RE: Hydrogen Energy California Project
Application for Certification 08-AFC-8

Responses to CEC Data Requests Set One (Nos. 1, 2, 11, 17, 31b, 32, 33, 36, 64f, 85 through 90, and 125 through 132)

Revised Application for Certification (08-AFC-8) for HYDROGEN ENERGY CALIFORNIA Kern County, California

ATTACHMENT 11-1
HECA OVERALL COMPONENT BALANCES

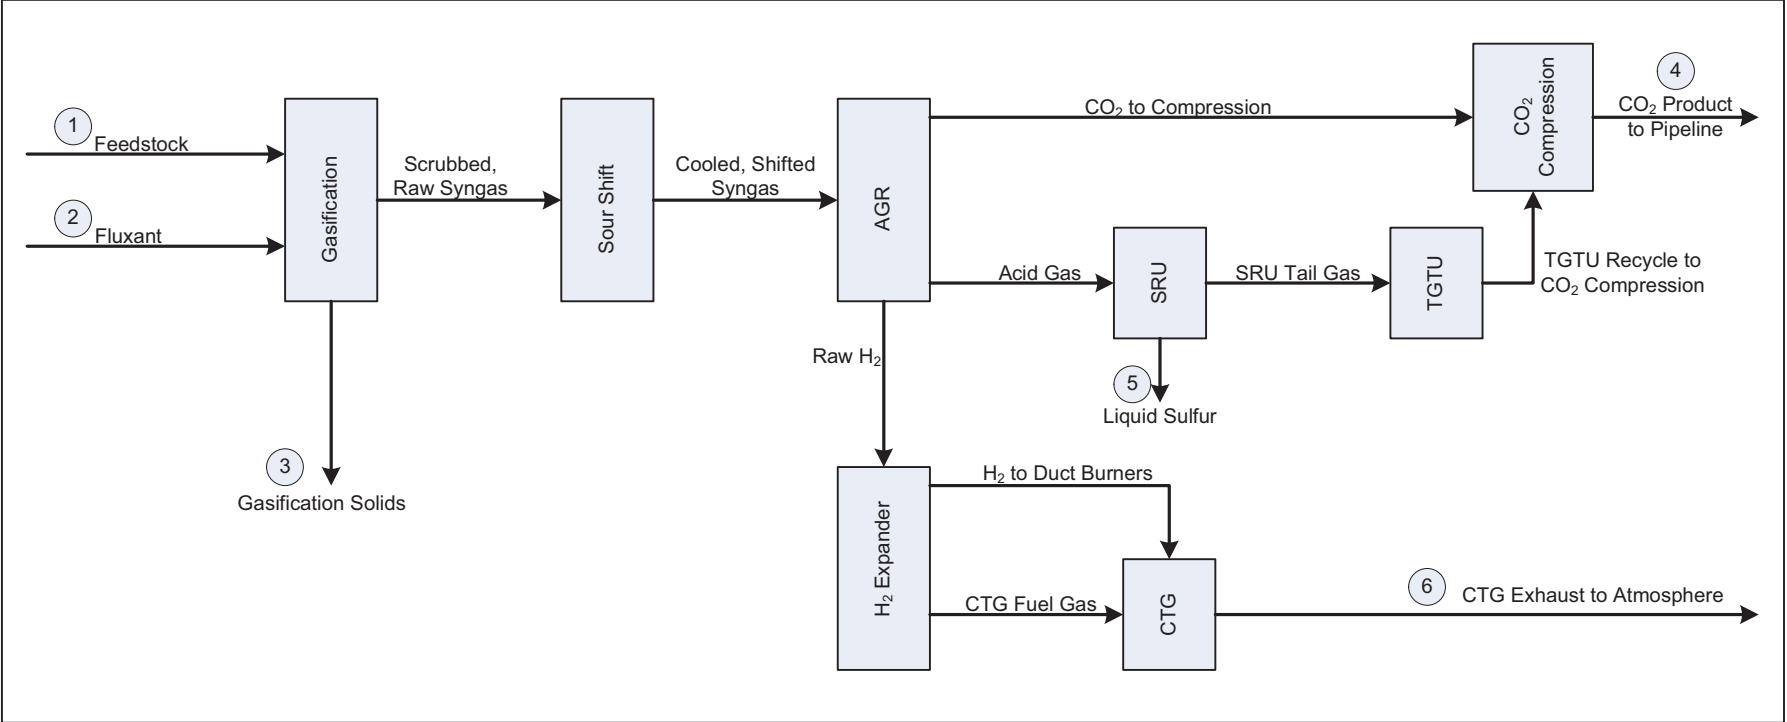
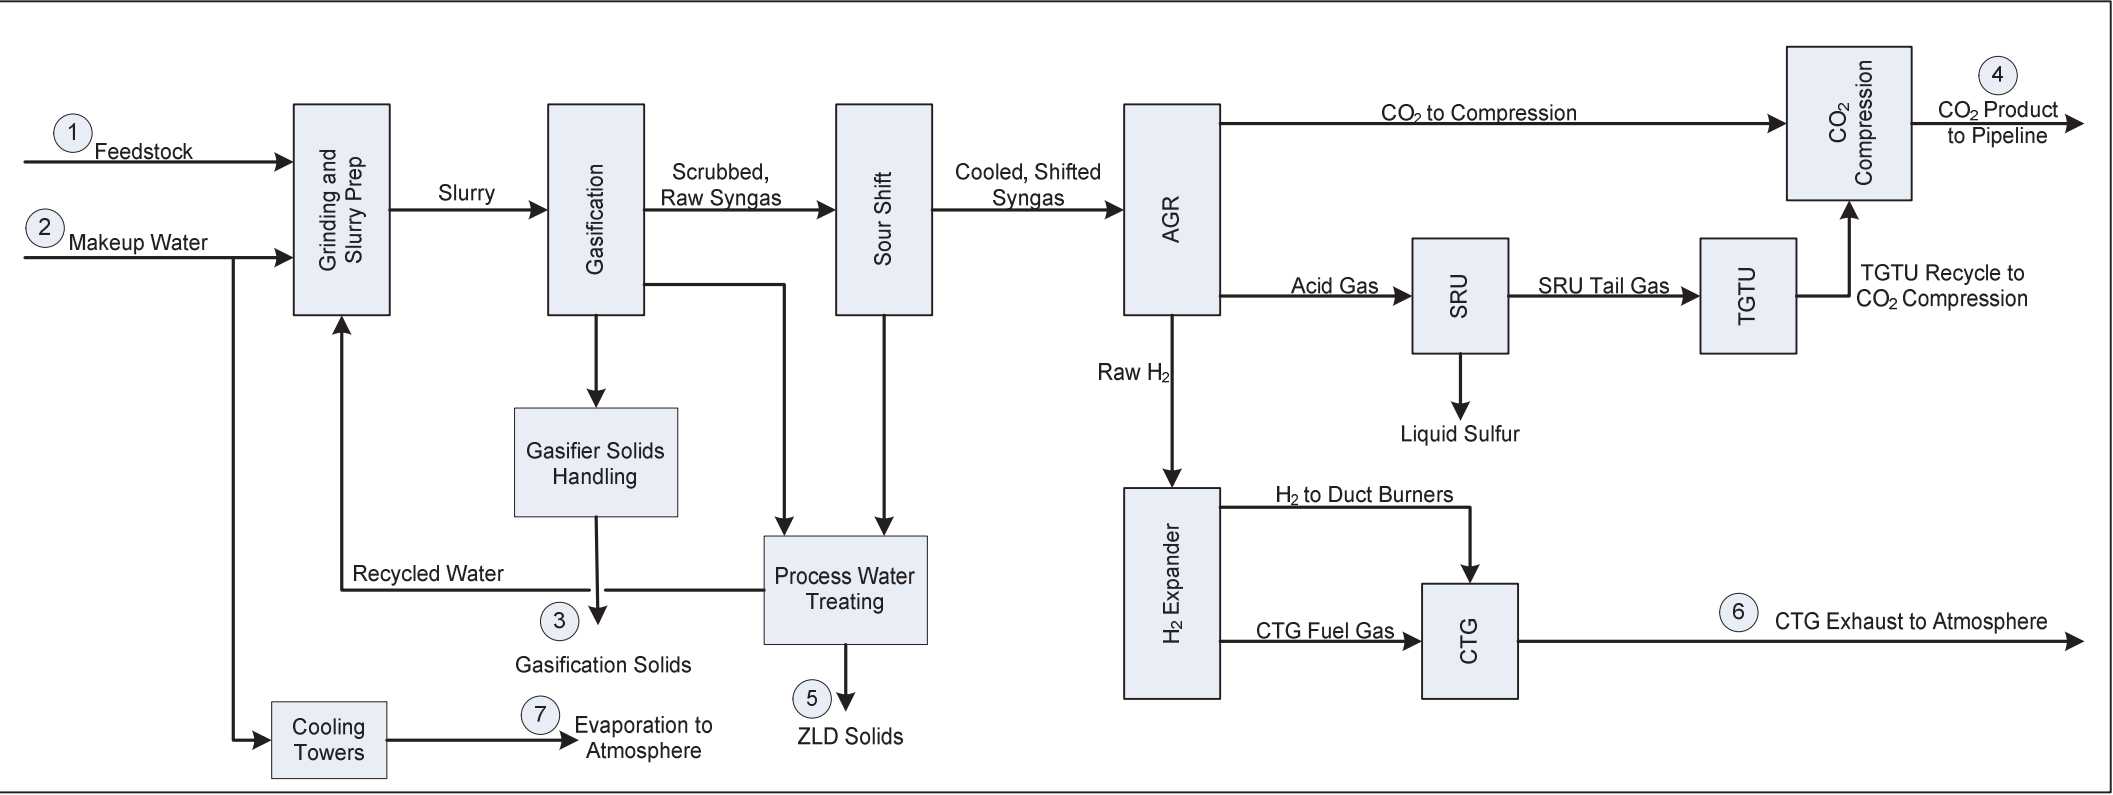
- 11. *Please provide energy and mass balance data for the gasification process for both petroleum coke and coal. The mass balance data should clearly show carbon, water, sulfur, volatile organic compounds (VOC), toxic air contaminants (TACs), and total solids contents throughout the process.***

Attachment 11-1 contains two diagrams that show the mass balance data for carbon, sulfur, total inert solids, and water. Data are shown for the 75 percent coal/25 percent petroleum coke case and the 100 percent petroleum coke case. Information showing mass balance data for volatile organic compounds and toxic air contaminants is given in the response to Data Request No. 17A, and will be provided in the responses to Data Request Nos. 17B and 89. Please refer to those responses. Energy balance data was provided with the Revised Application for Certification (AFC). Please refer to Revised Table 2-11, Representative Heat and Material Balances, from the Amendment to the Revised AFC, included below.

FIGURE 32-1

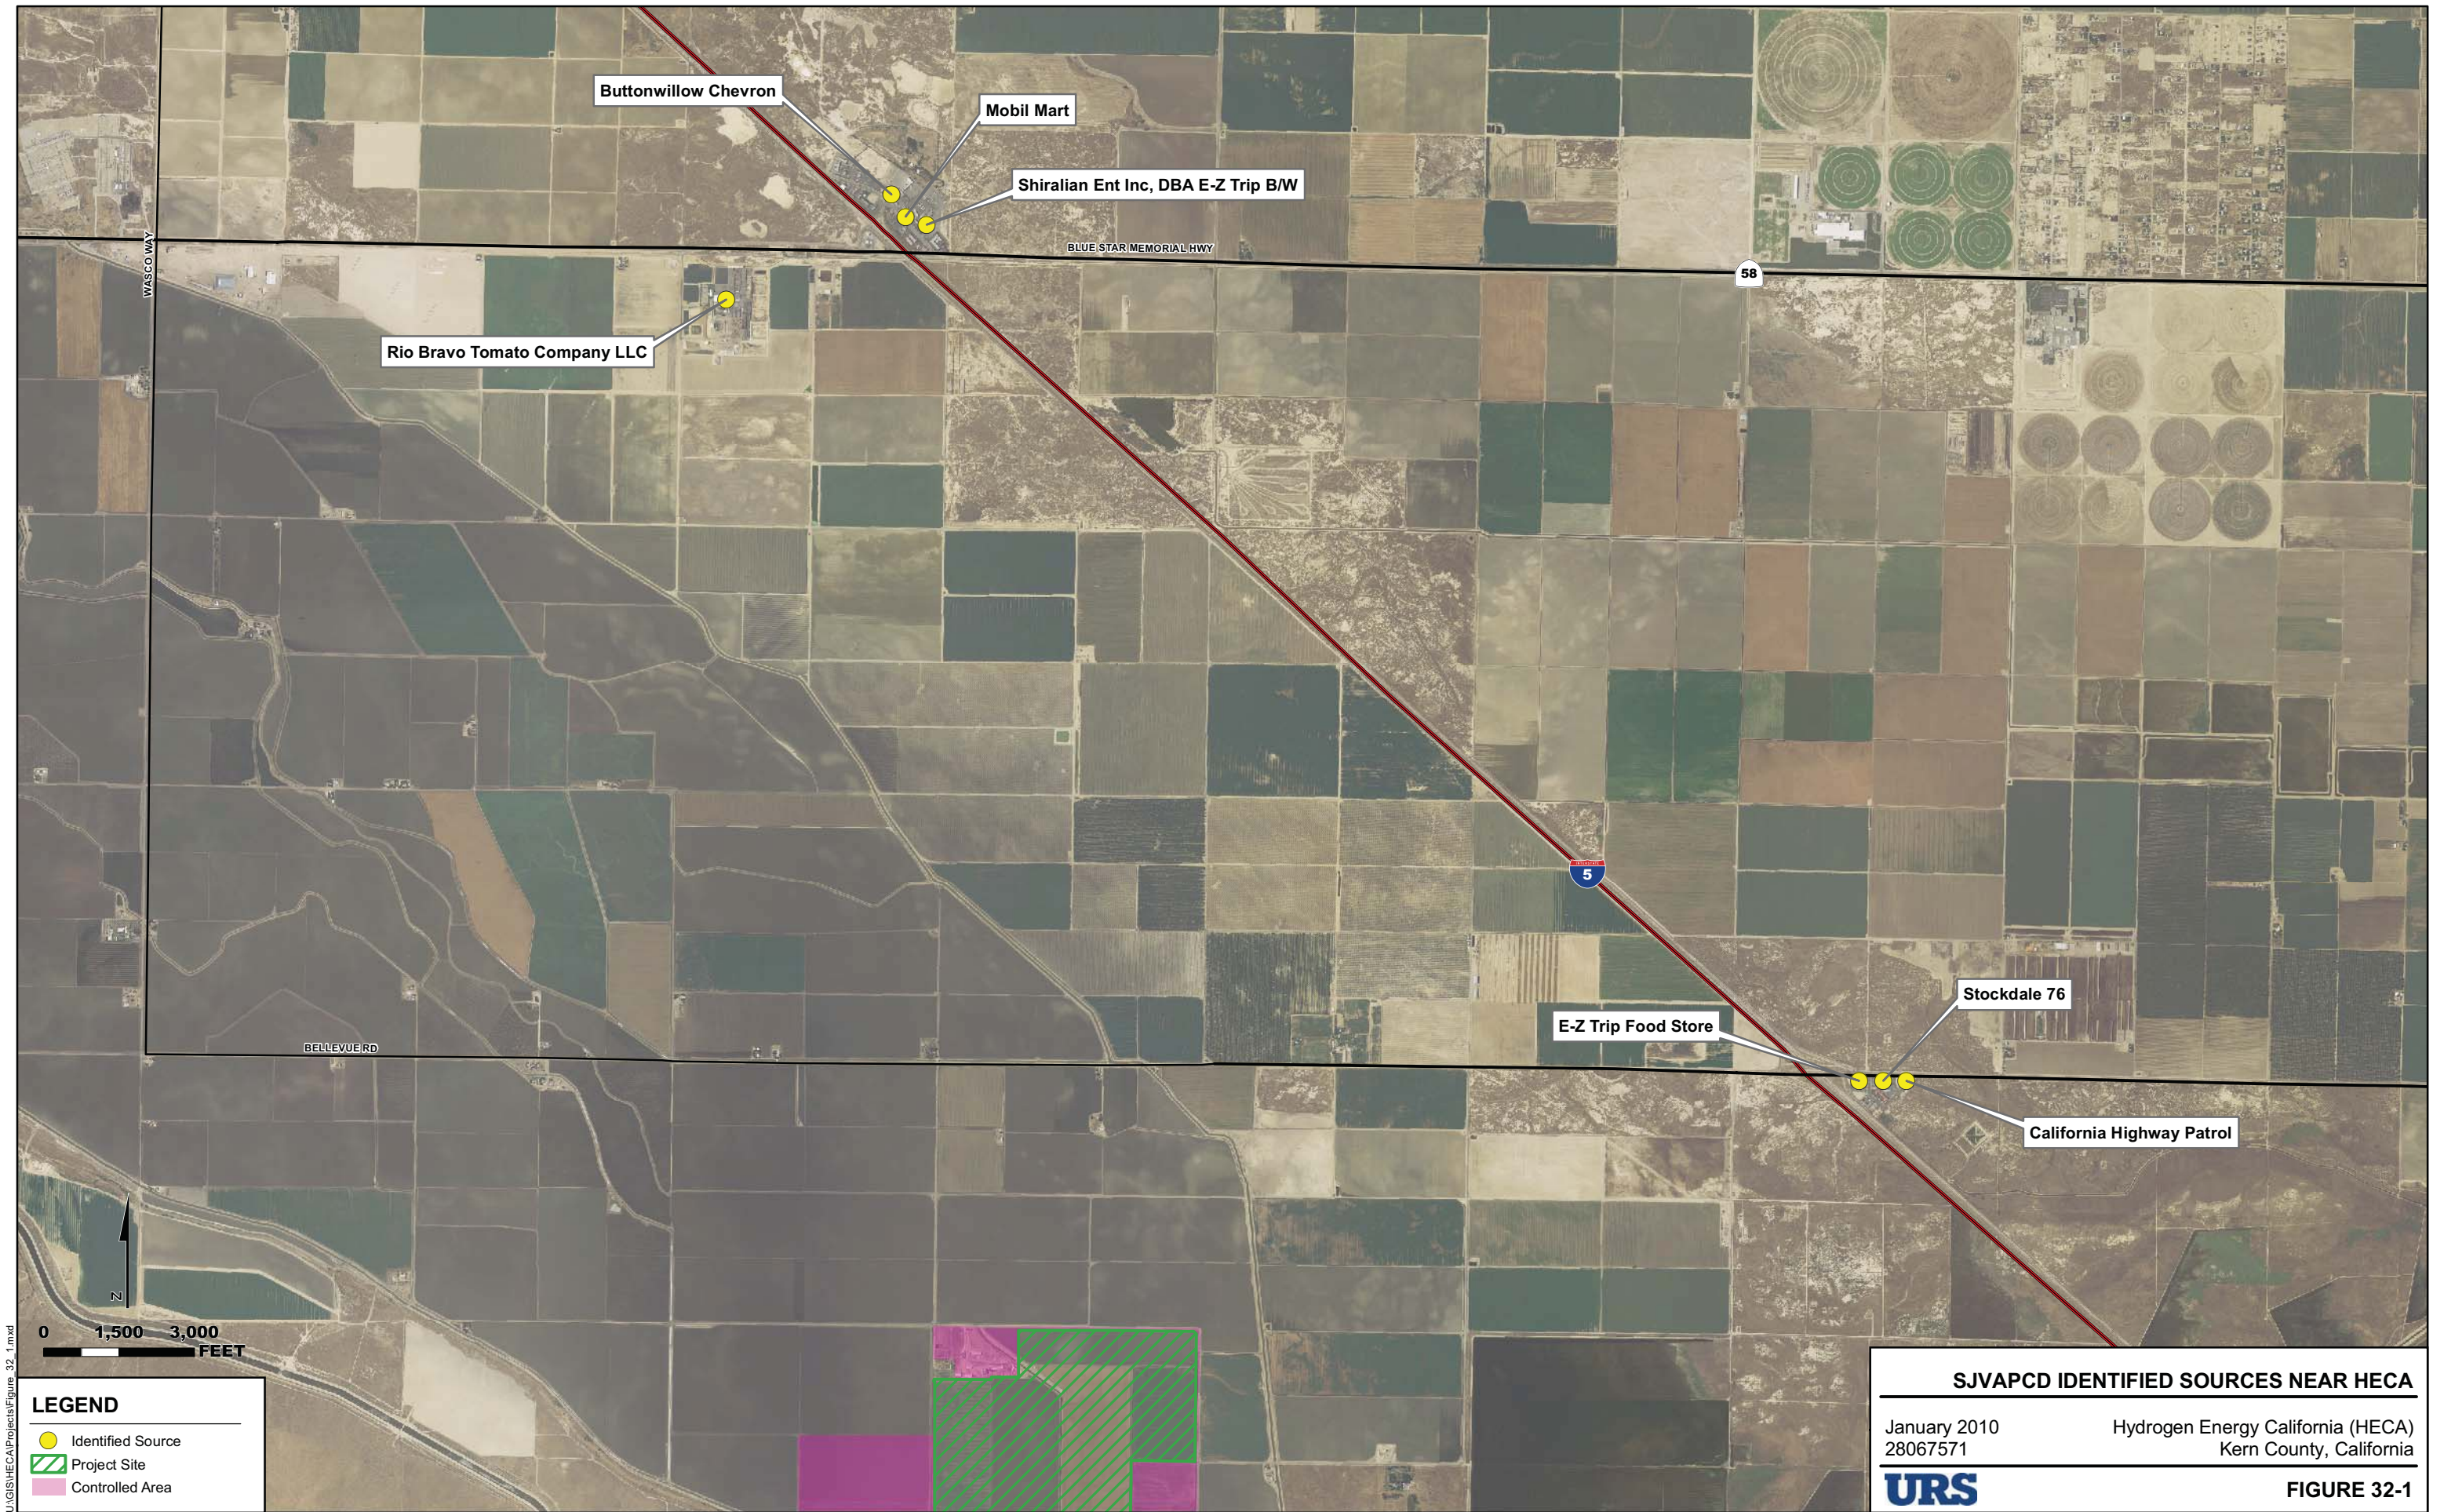
- 32. *Please provide a list from the SJVAPCD of large stationary source projects with permitted emissions, for projects with greater than 5 tons of permitted emissions of any single criteria pollutant, located within six miles of the project site that have been recently permitted, but did not start operation prior to 2009, or are in the process of being permitted.***

A public records request was submitted to the SJVAPCD requesting the list of sources meeting the criteria specified in this data request; a copy of that request is included as Attachment 32-1. SJVAPCD responded with a list of sources, a copy of which is included as Attachment 32-2. There are no sources on the list that meet all of the criteria for inclusion specified in this data request. Specifically, all sources on the list emit less than 5 tons per year of any single criteria pollutant. Therefore, there are no sources to be included in the cumulative impacts modeling requested in Data Request 33. For information purposes only, all the sources from the SJVAPCD list are located and identified on Figure 32-1.
